RE: SINSW SUBMISSION – GILEAD STAGE 2 PLANNING PROPOSAL (PP-2022-3978)

ATTACHMENT A – SINSW SUBMISSION – GILEAD STAGE 2 PP

Figure 1: Draft Structure Plan

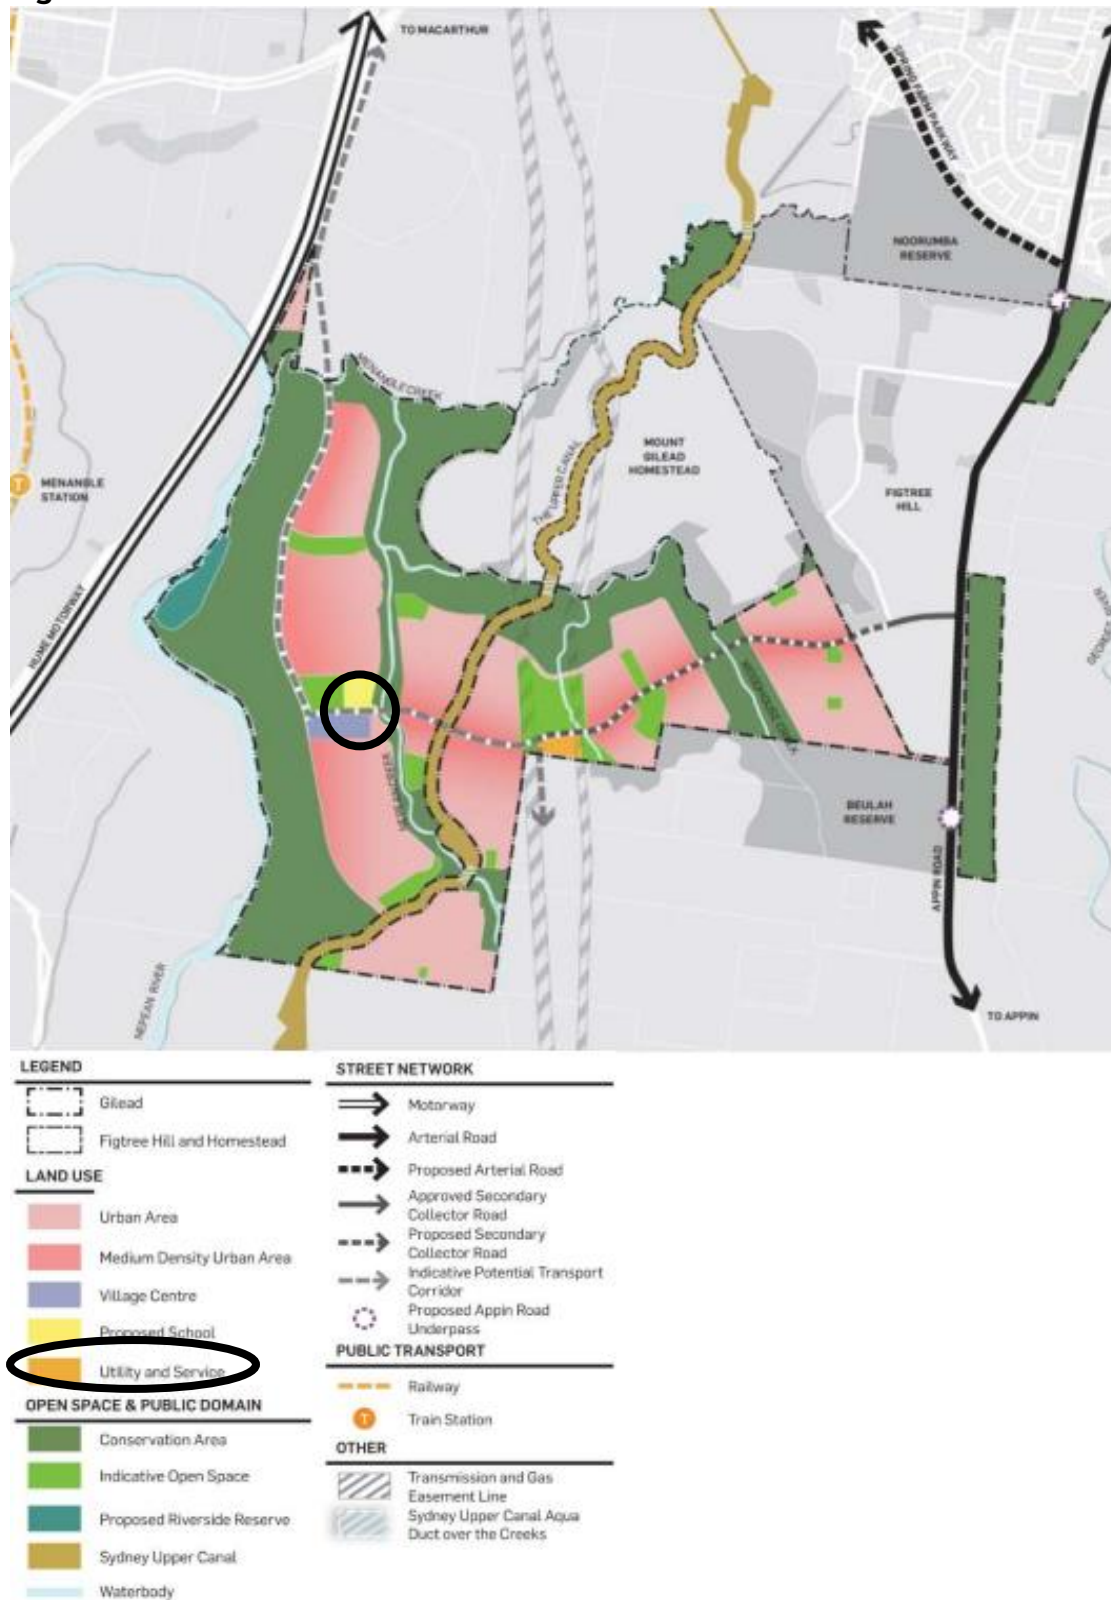
SINSW notes that the draft Structure Plan identifies one potential school site (refer Attachment A below). The specific location and details of this site will be the subject of ongoing discussions between SINSW, DPE and the developer as detailed planning progresses for the Precinct.

SINSW has reviewed both the draft Structure Plan for the study area and request that any commentary and/or mapping within the proposal package which addresses the potential school sites be amended to refer to this site as:

“Potential education facilities”

As stated above, the draft Structure Plan identifies one school site in proximity to the proposed town centre. SINSW’s ‘School Site Selection and Development Guidelines’ outline the site-based requirements for any new school site. These have been previously provided to Council and DPE for the proponent’s consideration and are also available at:
